ARKANSAS NUCLEAR ONE - UNIT 1

IMPROVED TECHNICAL SPECIFICATIONS SUBMITTAL

**05/01/01 Supplement
Volume 1 of 2
(Sections 3.3A, 3.3B, 3.3C, and 3.3D)**

May 1, 2001

Table 3.3.1-1 (page 1 of 1)
Reactor Protection System Instrumentation

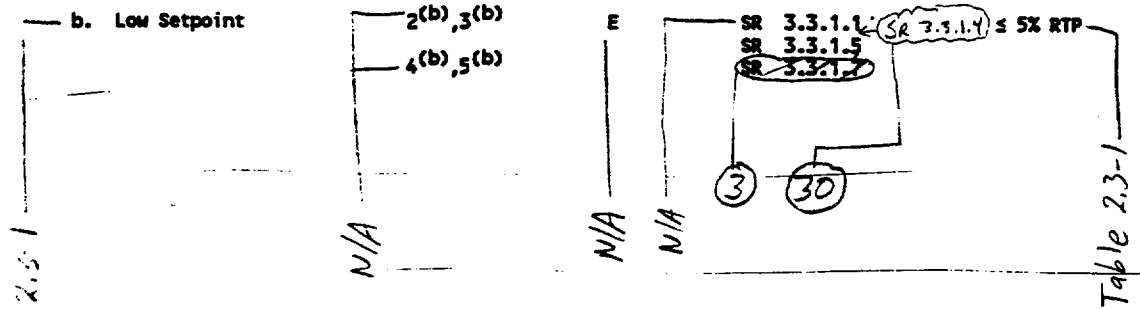
RAI 3.3.1-06
